ADDENDUM NO. 1
PROPOSAL FOR FURNISHING ALL LABOR, MATERIALS, EQUIPMENT, TRANSPORTATION, SUPERVISION, PERMITS, ETC. NECESSARY FOR THE NIRC – C06 NOVEL MACAQUE BREEDING RUNS, LOCATED AT THE UNIVERSITY OF LAFAYETTE CAMPUS IN NEW IBERIA, LOUISIANA.

Due Tuesday, June 11, 2024 - 2:00 PM Solicitation No. 24214

Item No. 4 - Change to the Plans:

1 Plumbing Plan
 0 1" 8"
 NORTH

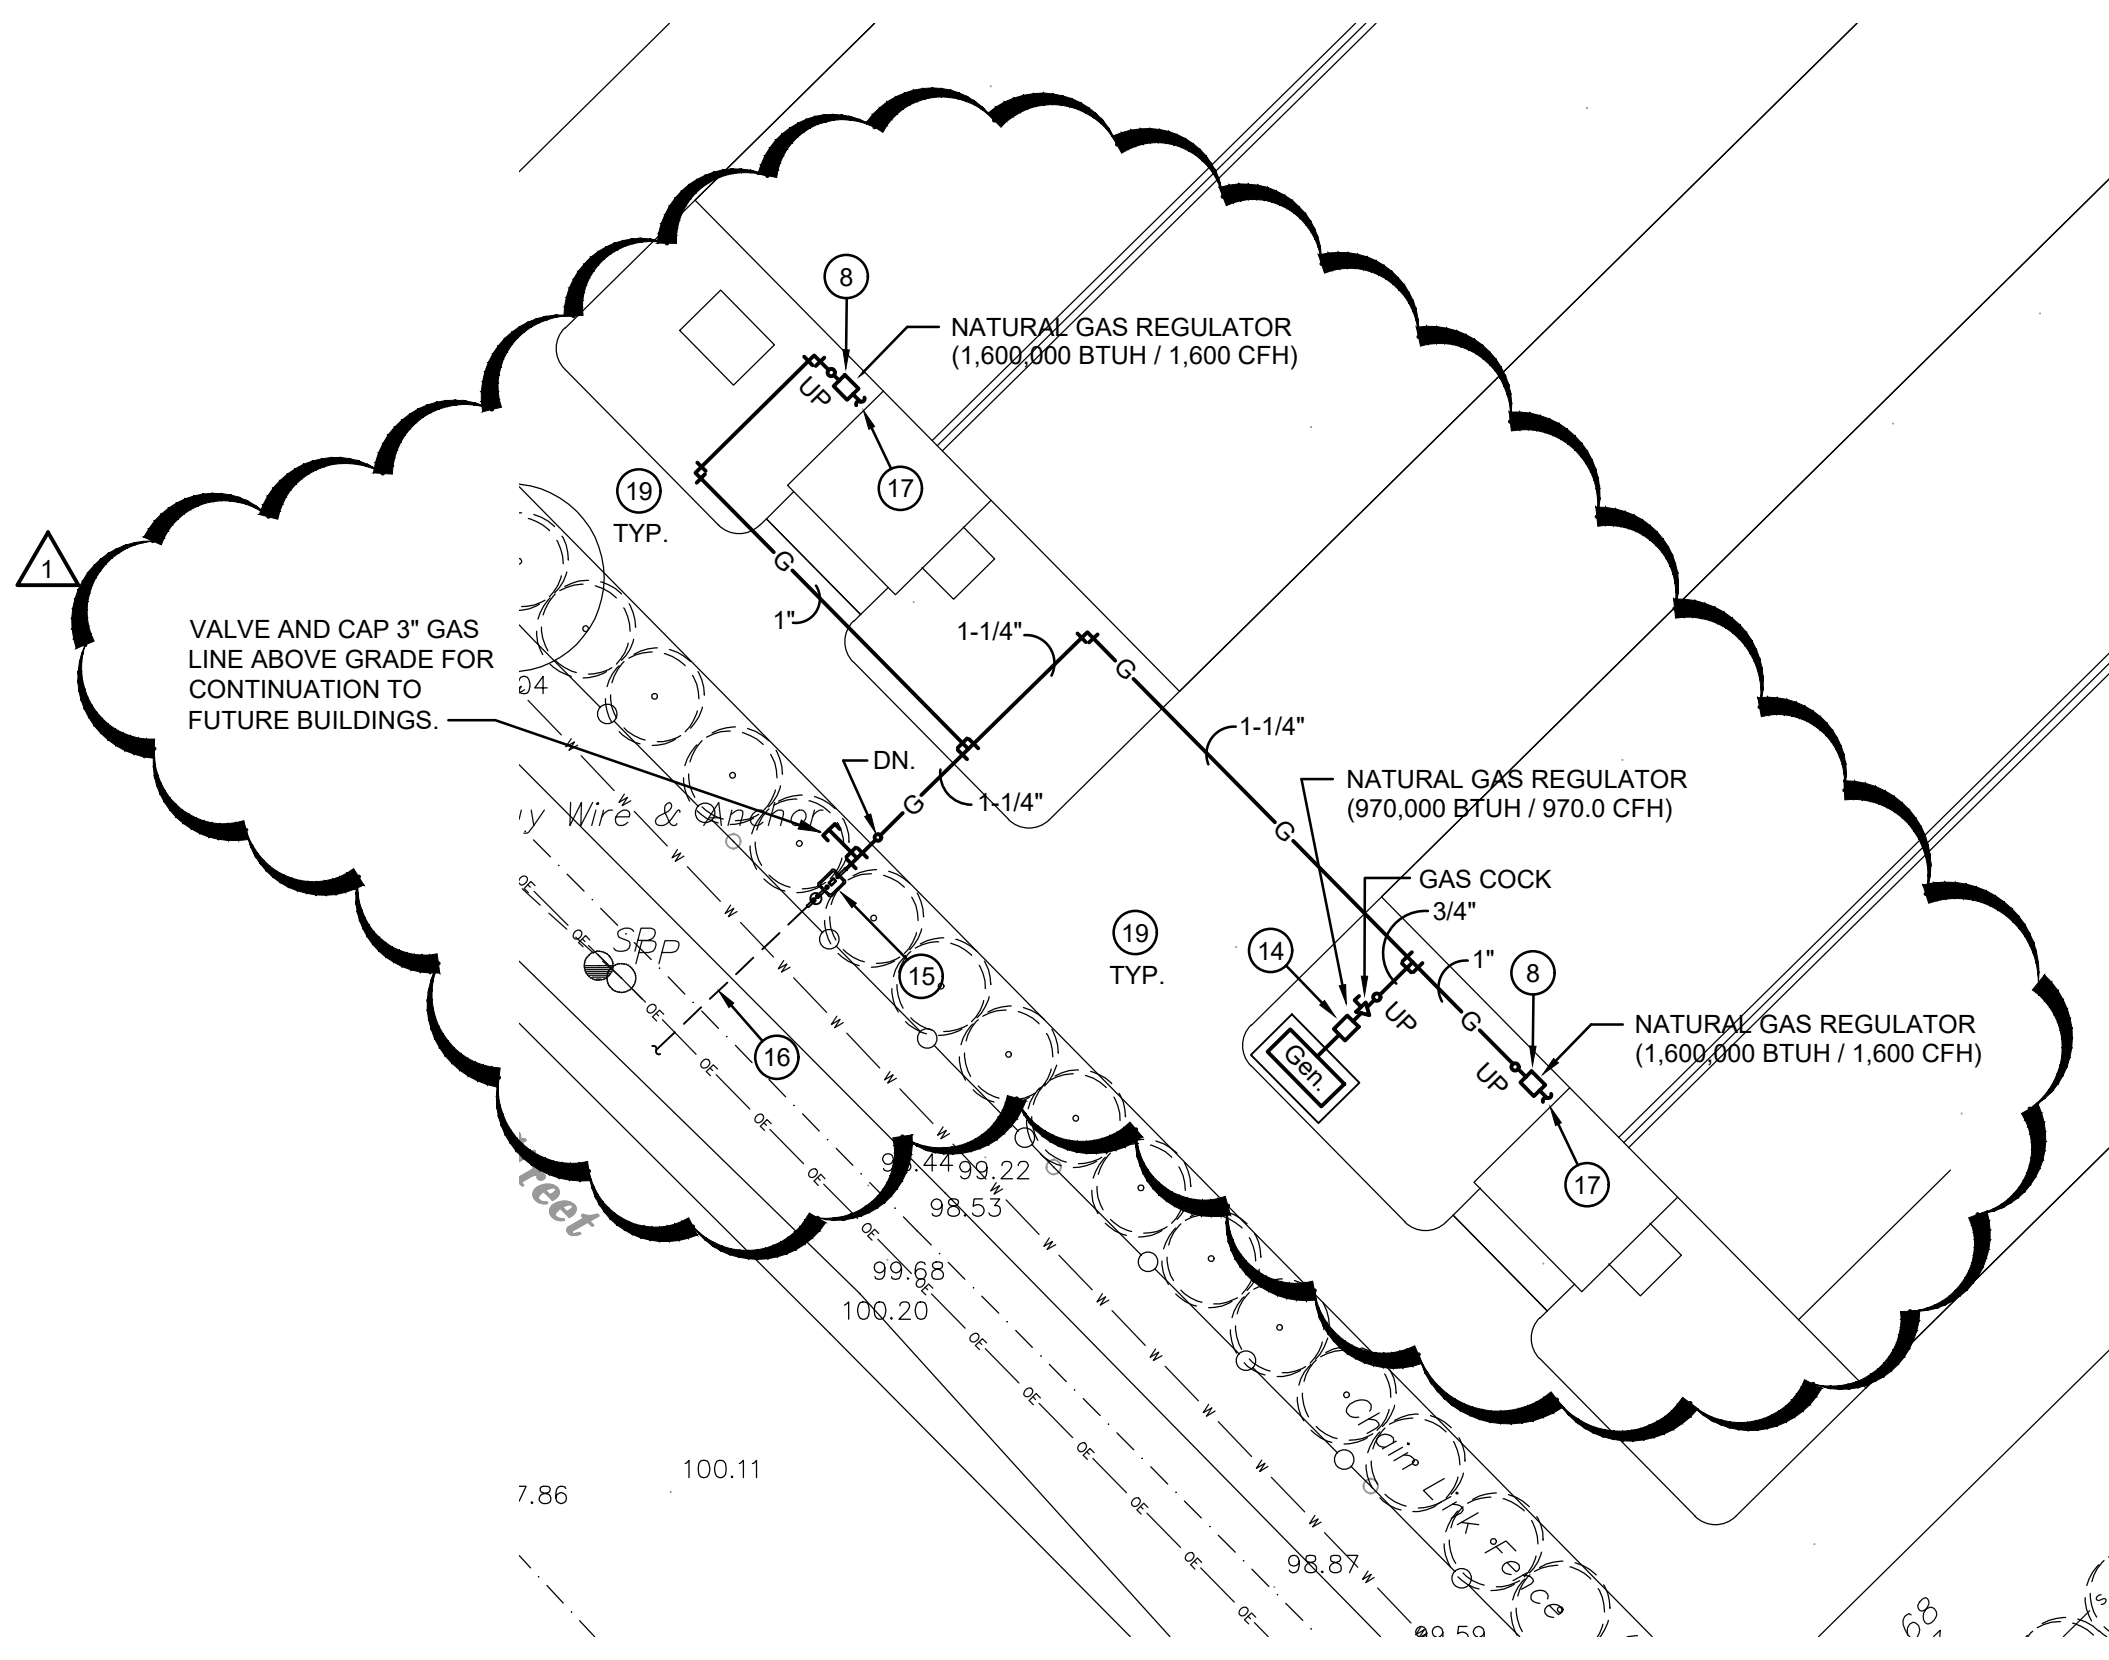
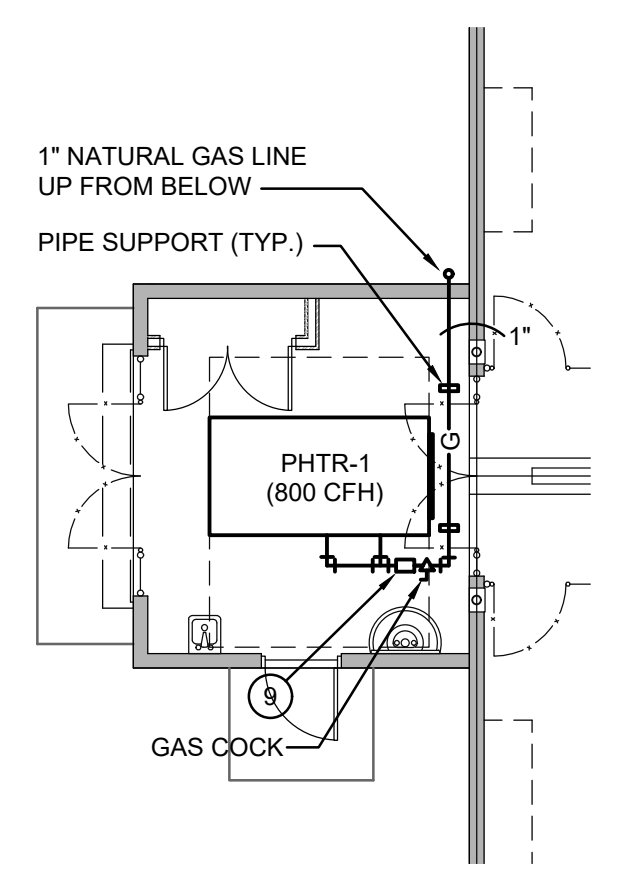
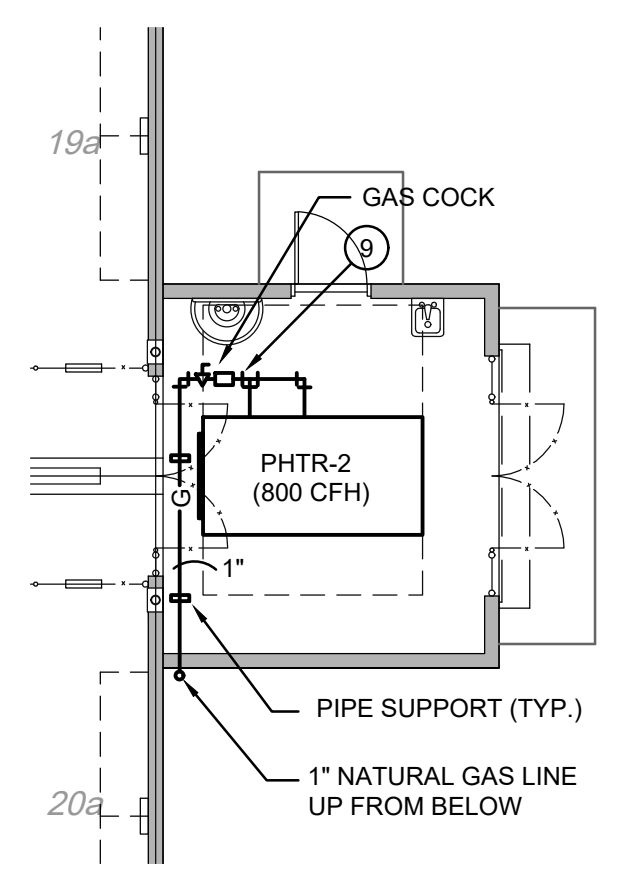
Replace Sheet P2.1 with the attached Sheet P2.1R. Contractor shall include all work as indicated on the revised sheet.

Replace Sheet P3.1 with the attached Sheet P3.1R. Contractor shall include all work as indicated on the revised sheet.

8 FLOOR DRAIN "FD-A" DETAIL
NO SCALE

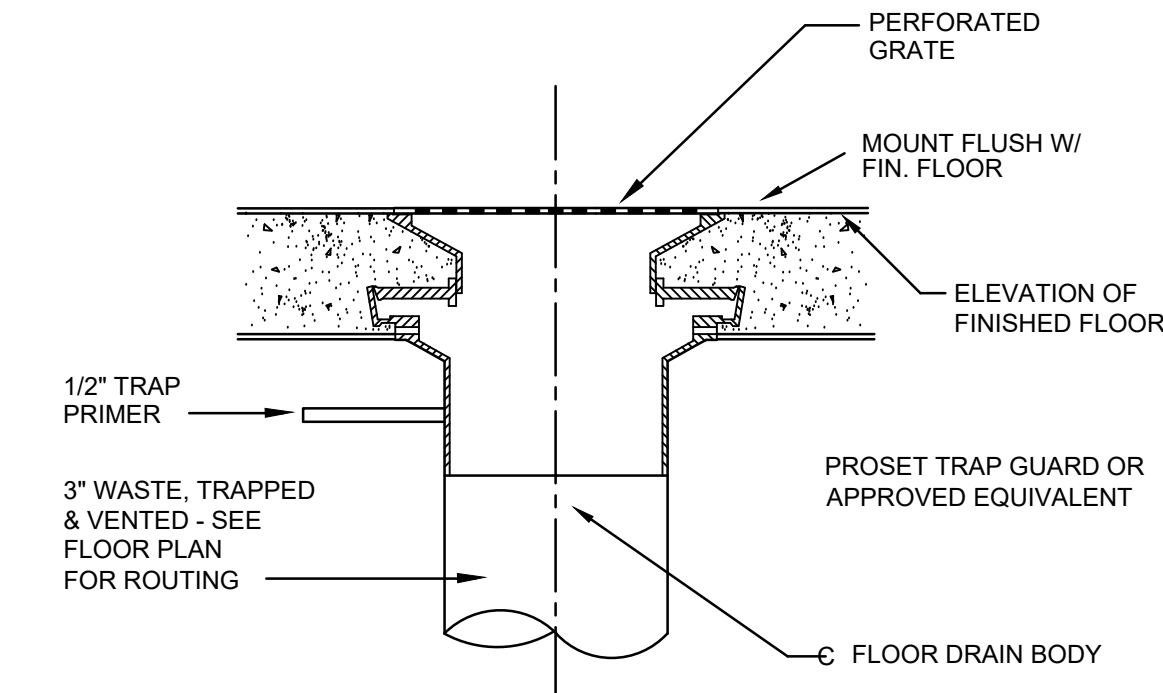
As clarification – two fur traps (fur interceptors) are required as indicated on C1.2, C1.3, C1.6 and as specified on P3.1.
